service bulletin

No. 88-13

Official Notification Under the U.S. Federal Boat Safety Act

Required Spark Plug Wire Replacement

Figure 1.

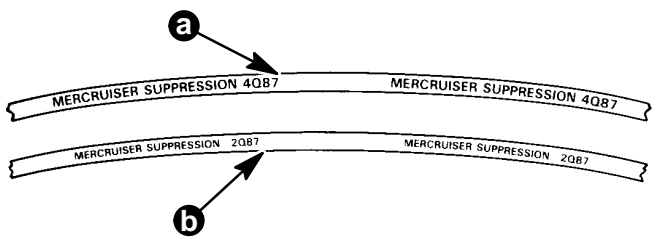
Insulation breakdown only occurs in a certain brand of spark plug wire supplied to Mercury Marine by a vendor. Refer to Figure 1 for identification of the two different wires. Inspect all wires on the engine or in replacement wire sets because sets may have both types of wires in them. If (a) type wire is found, order complete new wire set for engine. Refer to chart for correct ordering information.

- a - Approximately 1/8 in. (3.0mm) High White Printing on Wire - This Type of Wire Must Be Replaced
- b - Approximately 1/16 in. (1.5mm) High White or Yellow Printing on Wire - This Type of Wire is All Right to Use

Figure 2.

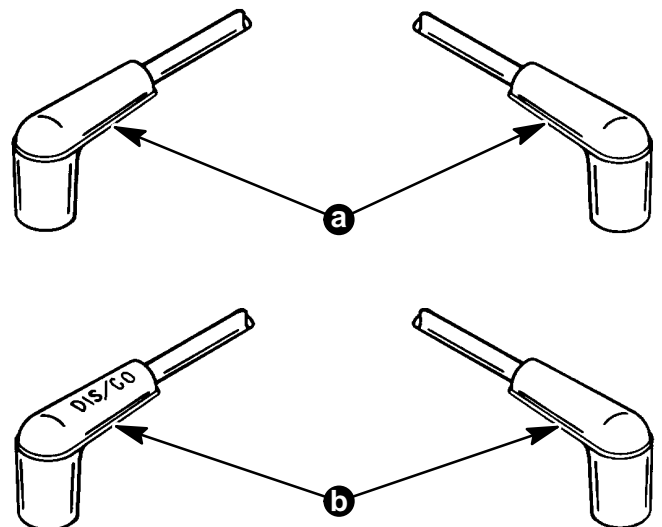
Thunderbolt IV (HEI) spark plug wires must be installed with black or DIS/CO boot on distributor cap only. DO NOT install black or DIS/CO boot on spark plug because boot will not withstand high temperatures given off by exhaust manifold. (Figure 2)

- a - Thunderbolt (HEI) Wire with a Black Boot on One End and a Gray Boot on the Other End - Black Boot Must Be Installed Only on Distributor Cap
- b - Thunderbolt (HEI) Wire with DIS/CO on Black Boot on One End and Plain Gray or Black on the Other End - DIS/CO Boot Must Be Installed Only on Distributor Cap
